5/5 Glengarriff
Conversion of Jatin lower rudder
to single plated balanced rudder
Lloyds Survey

Plan showing:-

Conversion of. Tulin
lower rudder to single
plated balanced rudder.

s.s. "Glengarriff"

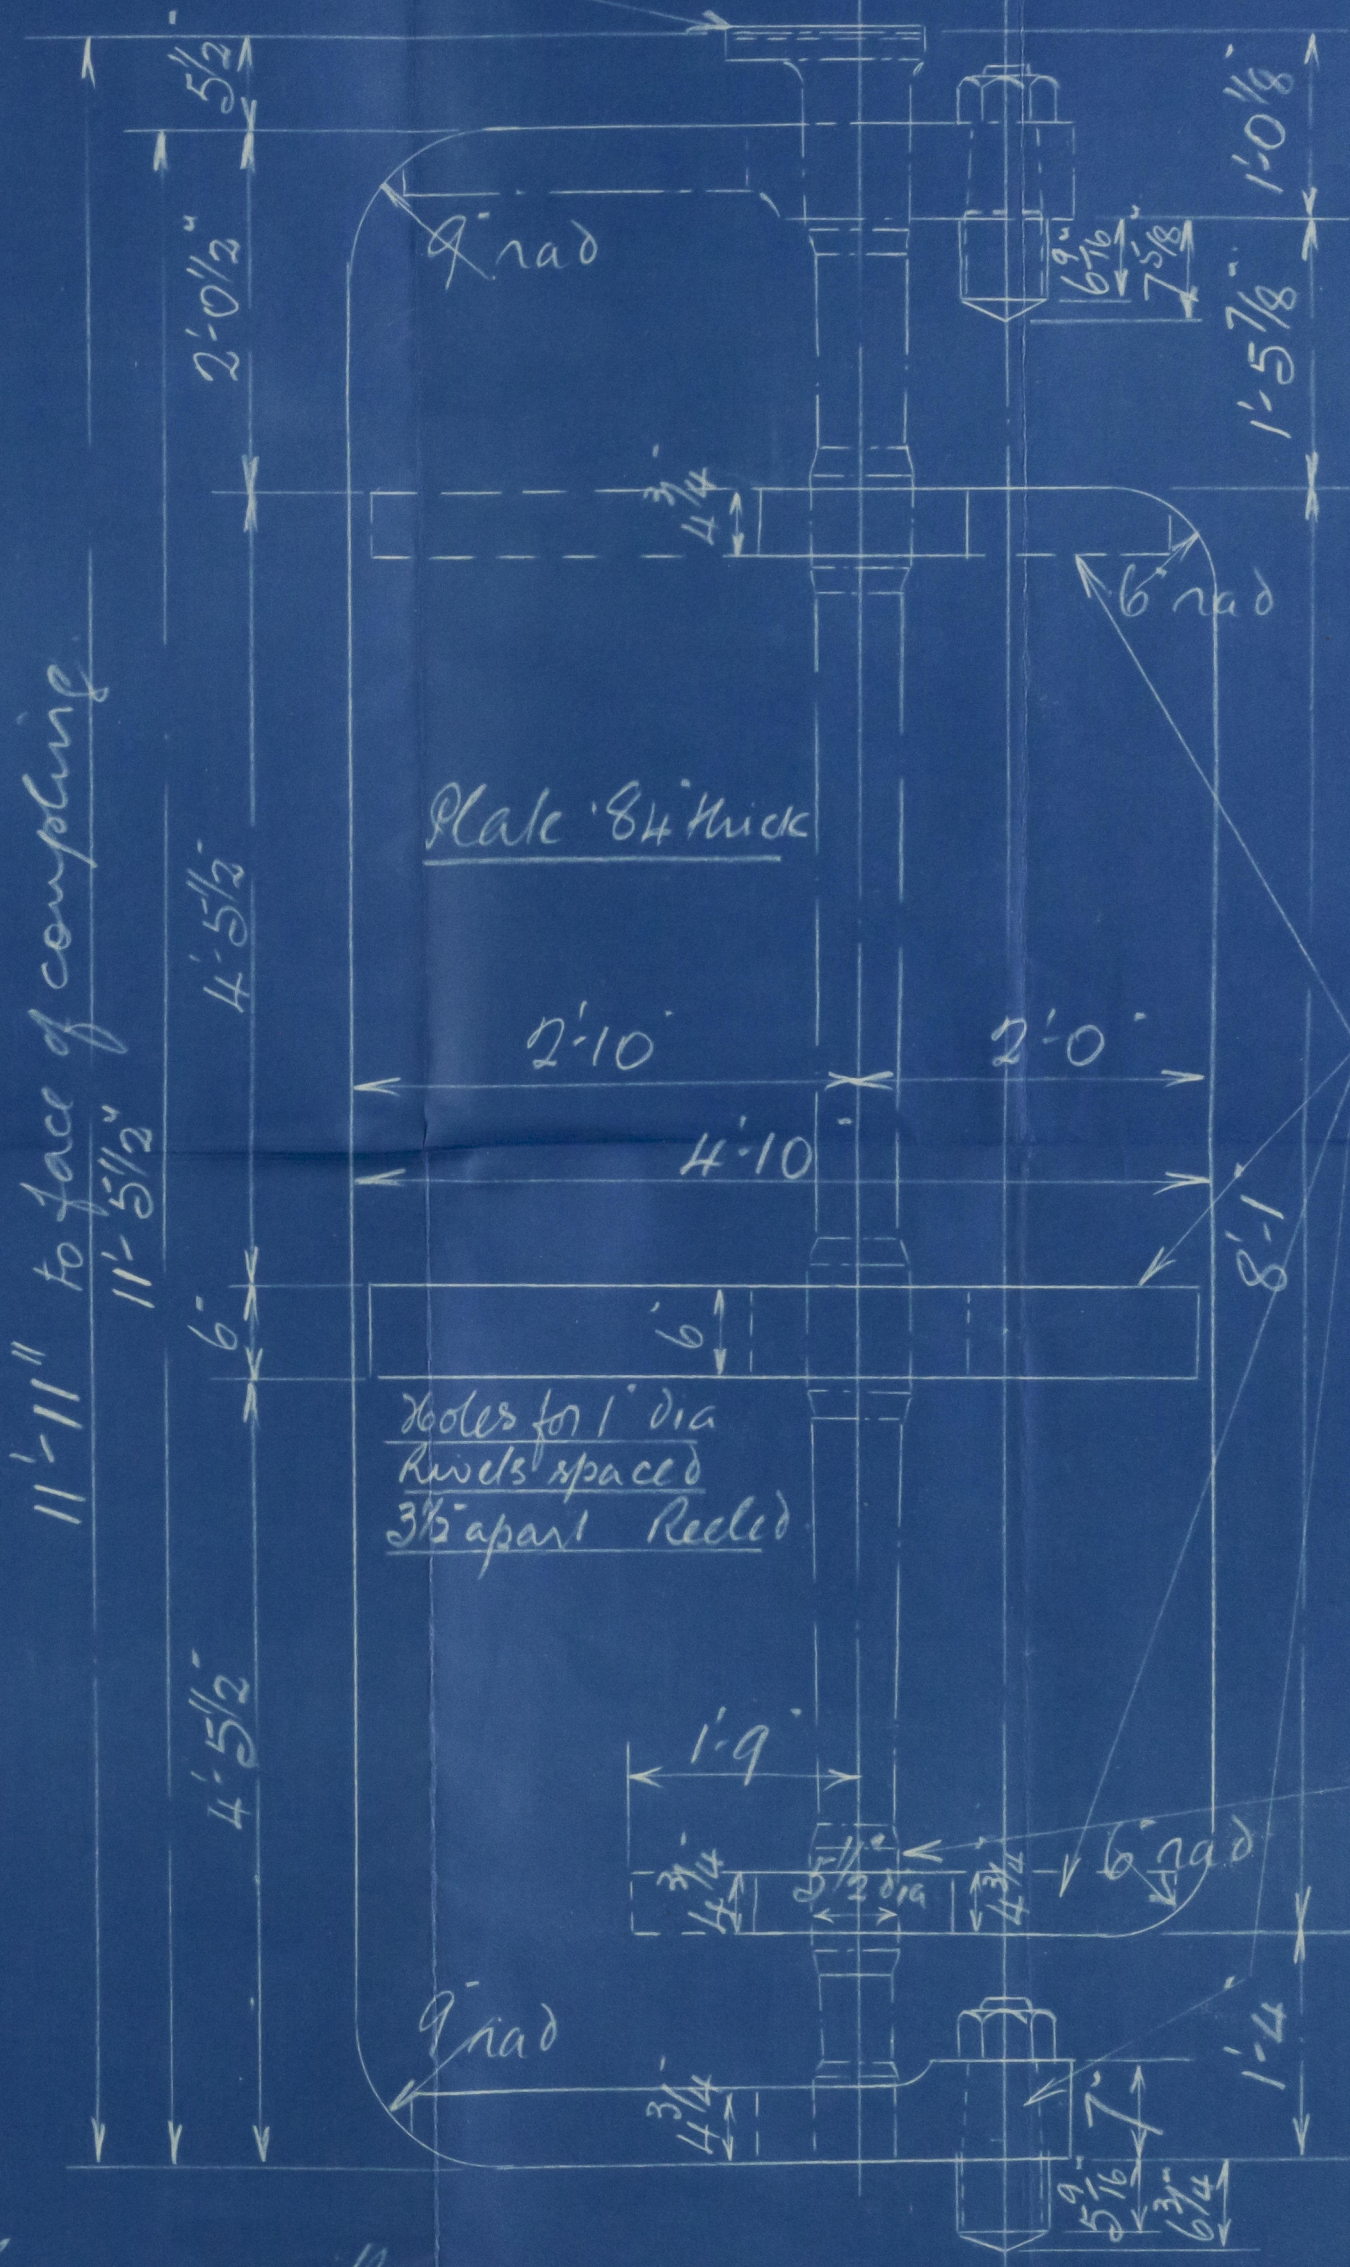
Note. Shallow keyway cut in coupling & new key welded in position.

Old lower rudder post & old top arm worked in

Note. New Brass Bushed Pinke supplied & fitted to old top arm. 5 9/16 dia over brass bush

Four new arms supplied & fitted to old lower post

Note. Old post built up here by electric welding & skinned up to form swell for new arm

Note. New Brass Bushed Pinke supplied & fitted in new bottom arm. 5 9/16 dia over brass bush
